FDEP File No. 0281232
Class V, Group 9, Exploratory Well
TECO Polk Power Station
Polk County

**NOTICE OF PERMIT MODIFICATION FOR
PERMIT NO. 0281232-001-UC**

MODIFICATION OF CONDITIONS PERMIT NO. 0281232-003-UC/M5

5.d. Exploratory Well IW-1 Construction details:

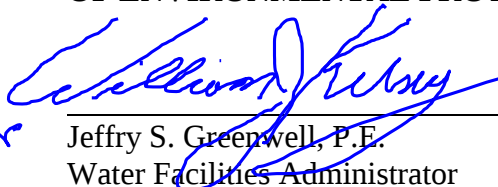
Permit Condition 4.c. and 5.d.

4.c. Department review and approval is required prior to the intermediate and final casing seat selection **for the exploratory well and DZMW-1**. Annotated copies of geophysical logs, lithologic descriptions and logs and water quality data (from drilling and packer tests) must be submitted to the Department in support of the proposed intermediate and final casing seat selection.

O.D. Inches/Type	Depth ft (bls)	Aquifer
52" / steel	± 300'	Surficial and Upper FL aquifer
42" / steel	± 1,200'	Upper Floridan
28" / steel	± 3,400'	Mid-Confining Layer & Lower Floridan
18" / steel	± 4,400'	Lower Confining Layer & Cedar Keys Formation
9.94" OD/ Fiberglass	± 4,400'	Lower Confining Layer & Cedar Keys Formation
16" open hole	± 5,300'	Lawson Limestone
12.25" open hole	± 5,800'	Taylor Limestone
